Strathfield Internal Development Assessment Panel Meeting

Thursday, 17 January 2019

REPORT: IDAP – Report No. 1

SUBJECT: DA2016/133/01 - 4 ALVISTON STREET, STRATHFIELD
LOT 18 SEC 5 DP 538

Figure 3: Streetscape Elevation of proposed addition.

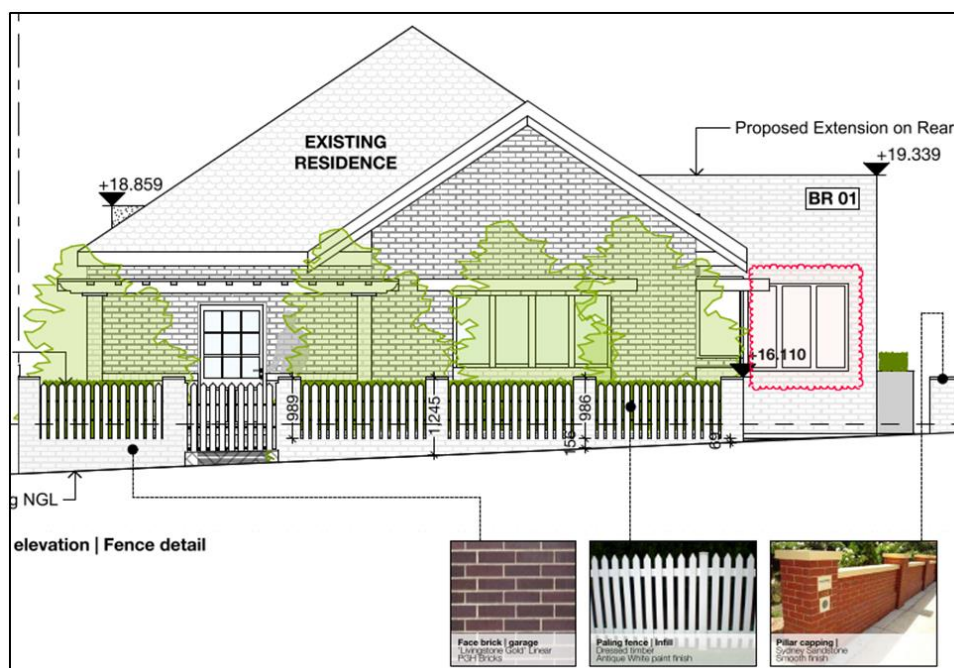
Comments: The rear addition is contemporary in style proposing a flat parapet roof form and the building materials chosen are sympathetic to the existing dwelling and do not detract from its heritage significance. The portion of the rear addition and basement entrance adjacent the eastern boundary and visible from the street is considered acceptable. The window on the wall facing the street has been amended to be of similar size, proportions and vertical spacing to the existing windows at the front of the house. This window adds an element of articulation and breaks up the visual impact of the wall, which was originally left blank.

maximum height of the fence is 1.52m from ground level and generally consistent with Council's control. The proposed height and design of the fence as shown in Figure 3 is deemed acceptable and sympathetic of the surrounding heritage character to Abbotsford Road.

Figure 4: View of existing front fence at 23 Abbotsford Road.

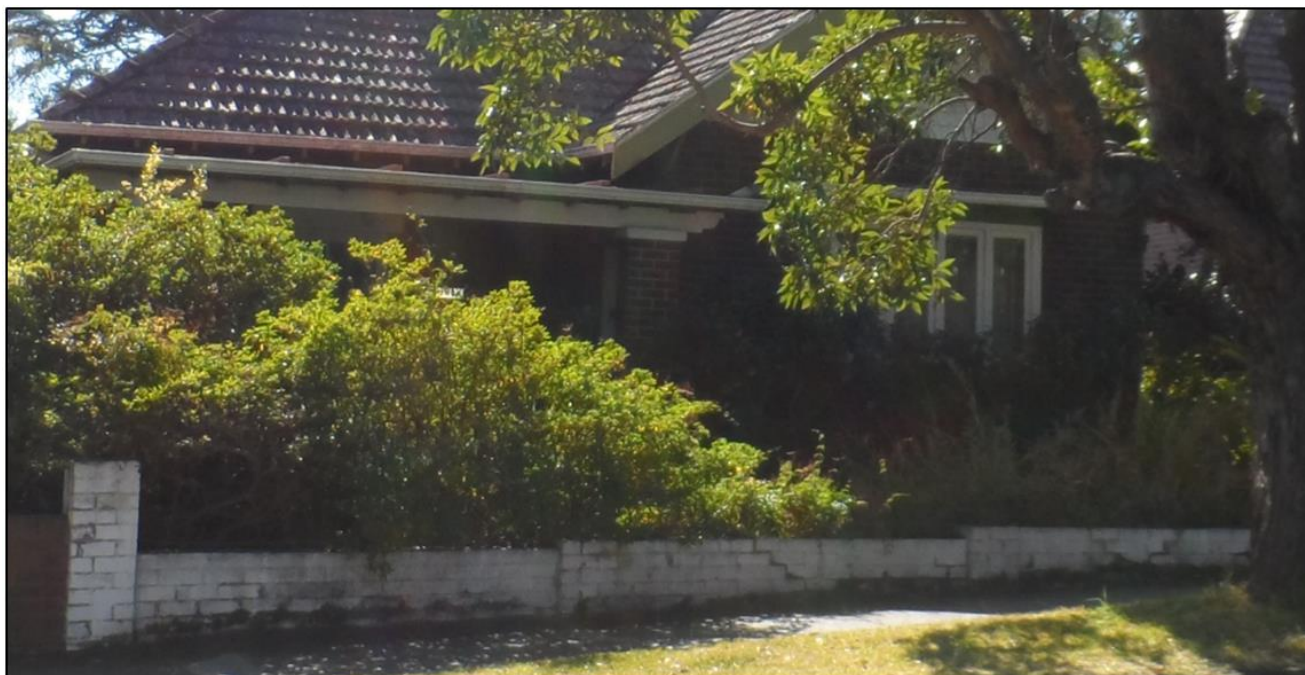
Comments: The existing front fence is in poor condition and has considerable cracks throughout the fence (shown in Figure 4). It makes little contribution to the Abbotsford Road Conservation

Figure 9: Proposed south-west rear balcony.

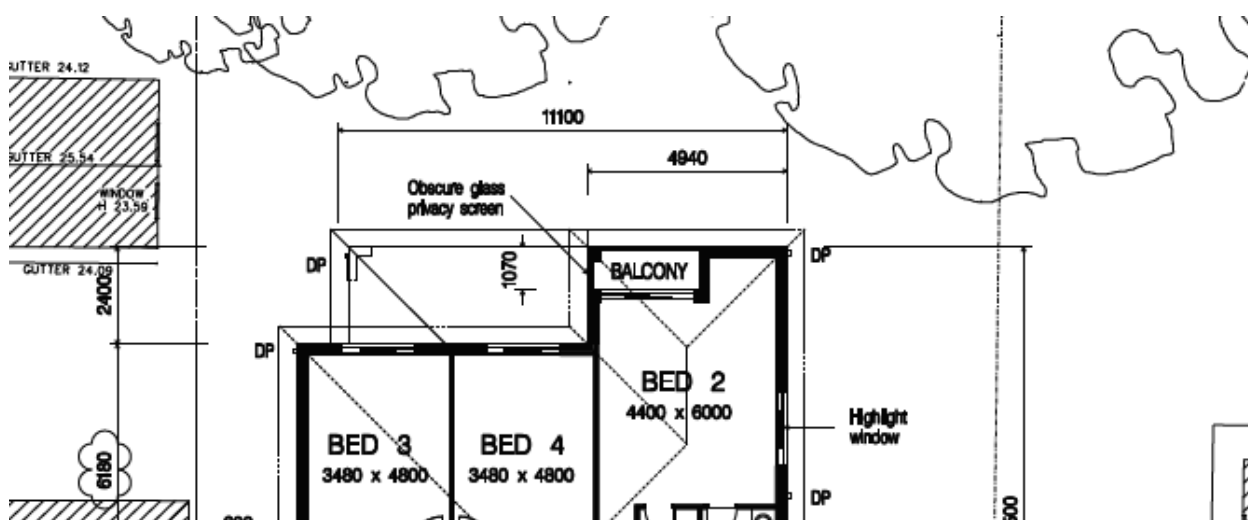
The side windows in the first floor bedrooms have sill heights of 1.7m and are unlikely to adversely impact upon the neighbouring allotments' privacy.

Figure 8: Roof space included in GFA calculation

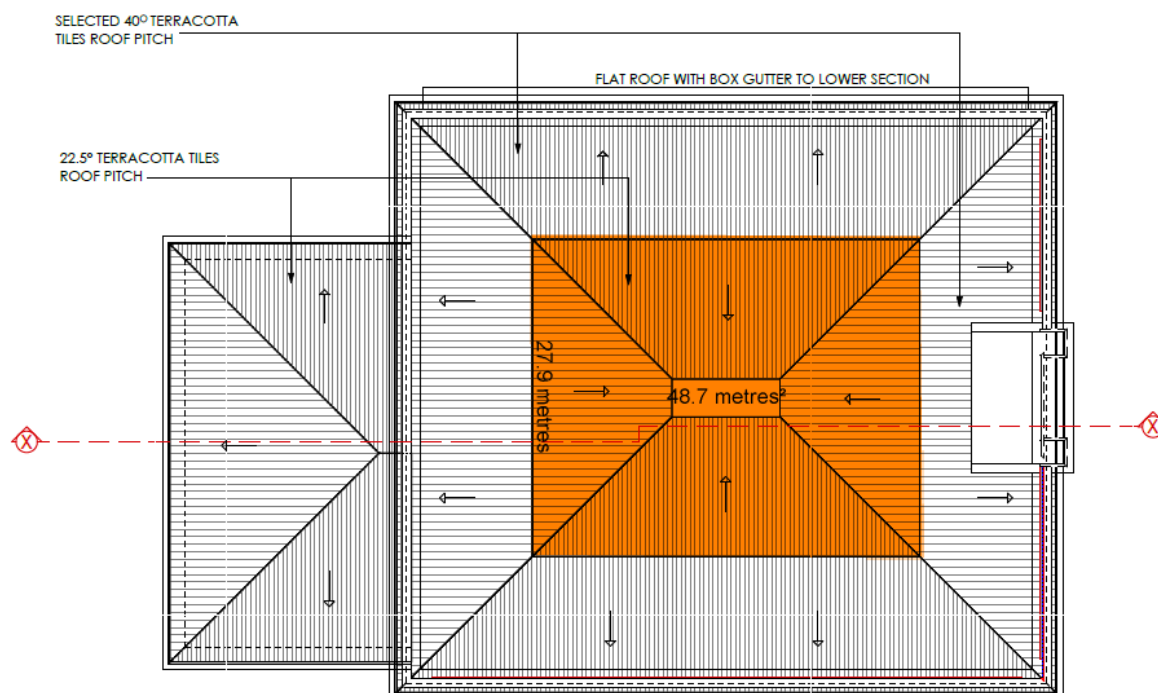
Comments: The development application proposes a gross floor area of 0.57:1 (227.6m²). However, as the roof form proposes a 22.5 degree pitch, the dwelling provides substantial area within the roof of a height up to 2400mm. The area constitutes a habitable attic and by definition adds a further 48.7m² of floor space, resulting in a technical non-compliance and a proposal with an increased gross floor area of 276.3sqm or 0.69:1. The proposed gross floor area exceeds the maximum permissible control of 0.65:1 (258.7m²) as defined under Clause 4.4C of the SLEP 4.4C 2012 and is not supported.

Council requested the pitch of the roof be lowered to eliminate habitable roof space and ensure compliance with the floor space ratio development standard. The applicant did not elect to revise the roof form, amend the plan or submit a request for variation pursuant to Clause 4.6 of SLEP 2012. As such, a condition of consent is recommended to ensure compliance with 4.4C of the SLEP 2012 (**Condition 1**).

Figure 9: A streetscape elevation of the proposed residential dwelling from Howard Street.

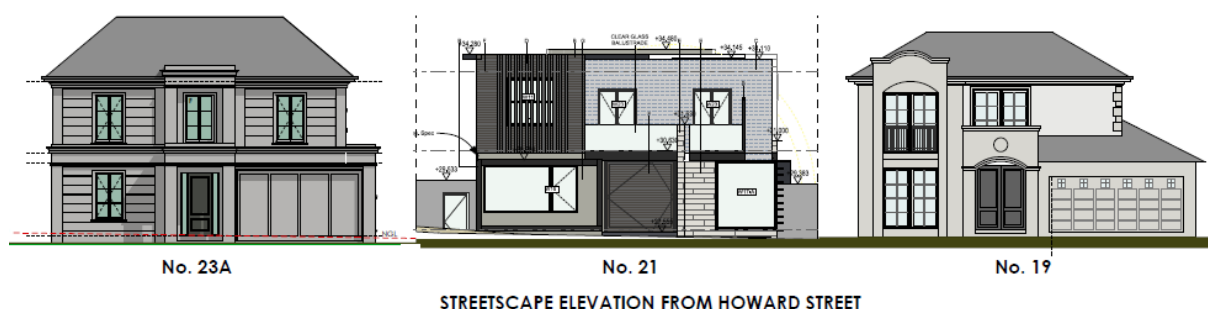
The portico protrudes above the RL of the eaves, which is contrary to Section 2.2.5.4 of the SCDP 2005. The non-compliance is minor and the dwelling house setback is consistent with the adjoining properties resulting in a proportional building façade that is unlikely to adversely impact on the streetscape. The dwelling located to the north (19 Howard Street) comprises a similar portico element which also protrudes above the eaves (Figure 9). The element, whilst strictly non-compliant, provides visual interest and depth to the front façade and is considered acceptable on merit.

Figure 10: Rear setback of proposed dwelling.

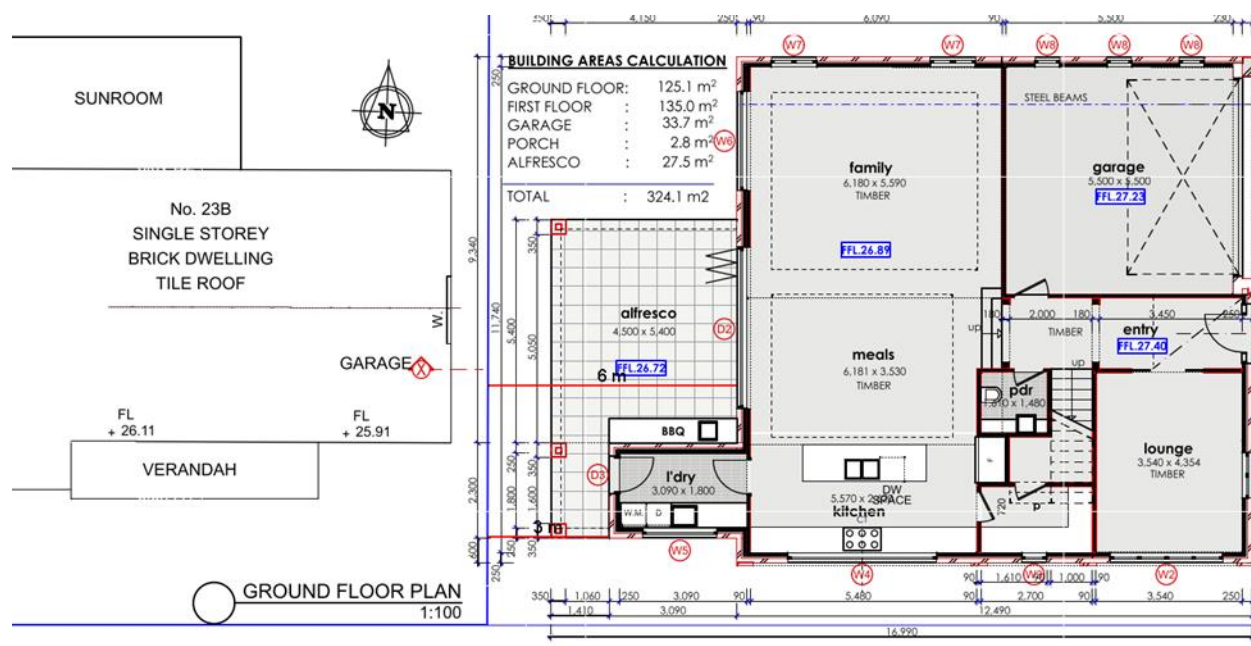
The design proposes an 8000mm front setback which is consistent and compatible with the prevailing setbacks provided in the streetscape which vary between 7000mm and 9500mm. Whilst the proposal provides a reduced rear setback of 3000mm, the departure is considered acceptable on merit due to the constrained lot dimensions resulting in a shallow depth. The dwelling largely complies with the minimum development control of 6000mm with the exception of the laundry which projects 3000mm into the rear setback for a distance of 1800mm (Figure 10). The interference is insubstantial and does not result in an unreasonable impact, being located adjacent to the secondary frontage. As such, the departure is acceptable on merit.

The proposed roof design provides a 40 degree pitch roof that results in a floor to ceiling height of 2400mm and a habitable attic level. The space within the roof is considered to constitute an additional residential level and consequent gross floor area in accordance with the SLEP 2012. This is not supported as gross floor area within the roof space would result in a dwelling which exceeds the development standard relating to Floor Space Ratio. In response, a condition is recommended to reduce the pitch of the roof so to eliminate habitable attic space and reduce the overall height of the dwelling (Condition 1).

Figure 8: Proposed rear balconies subject to the development application.

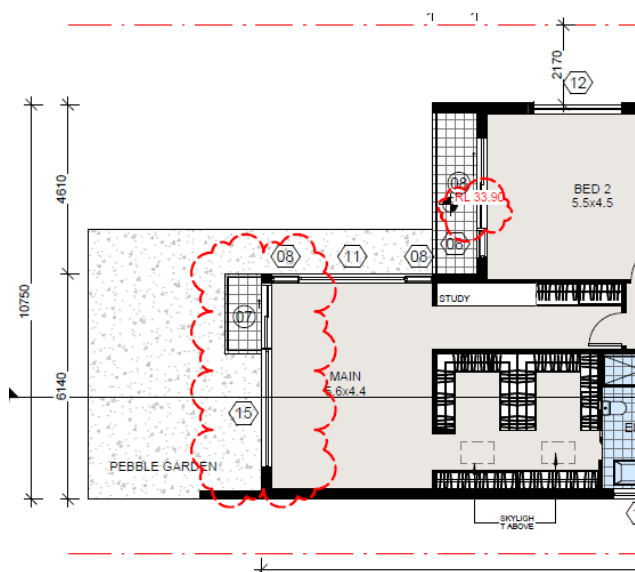
Comments: Four (4) balconies are proposed on the first floor of the dwelling (two being at the front and two at the rear). The location and size of the balconies orientated to Newton Road are amenable in supporting greater passive surveillance of the public domain, without compromising visual privacy of adjoining properties.

Amendments to the proposal resulted in a reduction in the size of the southern rear balcony to a maximum dimension of 2000mm in length and width of 1000mm. However, the western rear balcony remains large, exceeding the maximum length 2000mm defined by the DCP and subsequently does not comply with Section 7.2.3(3) of the SCDCP 2005. The balcony is deemed satisfactory given the generous setback 13.4m from the rear boundary and subsequent separation from habitable rooms in the adjoining property located at 42 Newton Road and a variation to the development control is supported in this instance.
